#8 ZON2007-00643

#### PLANNED UNIT DEVELOPMENT

STAFF REPORT Date: March 15, 2007

**DEVELOPMENT NAME** Mobile Branch Partnership

### SITE PLAN

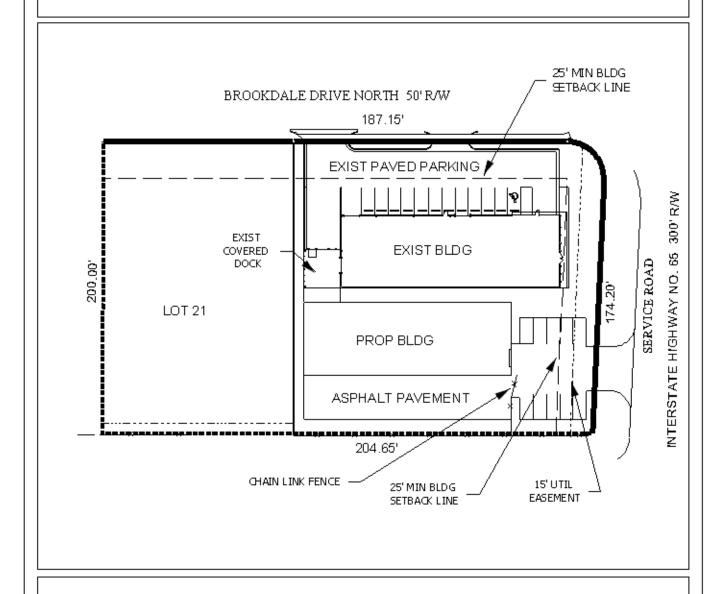
The plan illustrates the existing and proposed buildings, landscaping and green area, 12 existing parking spaces, and 9 proposed parking spaces. However, the plan does not illustrate compliance with the tree requirements of the Ordinance. As the proposed building exceeds 50% of the square footage of the existing building, full compliance with the landscaping and tree requirements of the Ordinance would be required. Additionally, since this site received a sidewalk waiver in 2004; therefore, no sidewalk along West I-65 Service Road West is required.

As 12' x 14' overhead door as illustrated on the plan within 58-feet of the front property line, and is a concern. Section 64-6.B.2 of the Zoning Ordinance, Off-street loading facilities states "Each large space shall have an overhead clearance of at least fourteen (14) feet, shall be at least twelve (12) feet wide, and shall be at least fifty (50) feet long exclusive of access or maneuvering area, platform, and other appurtenances". Therefore, if this site provides large truck loading the site plan must be revised to reflect the Off-street loading facilities requirements. Additionally, no dumpster is illustrated on the site plan.

**RECOMMENDATION** Based on the preceding, this application is recommended for holdover until the April 19<sup>th</sup> meeting to allow the applicant to address the following: 1) Provide information regarding Off-street loading facilities on the site plan; and 2) Illustrate dumpster location, access and screening on site plan. Information and revised plans must be submitted by March 26<sup>th</sup>.
